**TOWN OF ERIE
BOARD OF TRUSTEES MEETING
March 12, 2019**

SUBJECT: **Agenda # 19-127**

Review of Ranchwood Sketch Plan

PURPOSE: Review and comment on a Sketch Plan application for 220 apartment dwelling units and 64,500 square feet of commercial/office space on 6 lots.

Compliance with Town of Erie Comprehensive Plan:

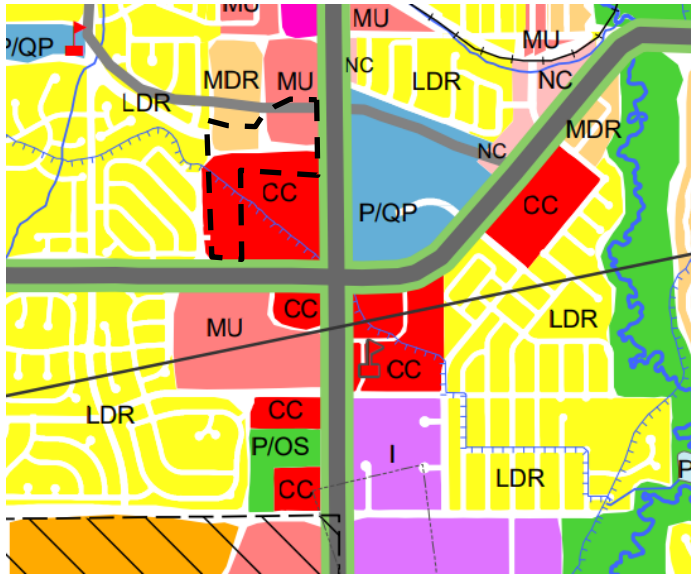
The majority of the property is designated as CC - Community Commercial on the Comprehensive Plan, Land Use Plan Map. Small areas of the site are also designated as MDR – Medium Density Residential and MU – Mixed Use. The CC designation provides a mix of general retail (e.g. grocery stores, larger retailers) and commercial services in a concentrated and unified setting that serves the local community. MDR areas should incorporate a mix of housing types and recognizable community centers such as park, recreation, and neighborhood or community commercial areas in a neighborhood setting. MU areas should provide a mix of residential at 6-12 du/ac, commercial, retail, and office uses in a compact, pedestrian-oriented environment. The submitted site plan does not meet the definition of CC and MU per the characteristics, as the Sketch Plan proposes developing most of the site as residential with some commercial land uses. The proposal would be consistent with the small area of MDR as the proposed development would provide a density of 7.67 du/ac.
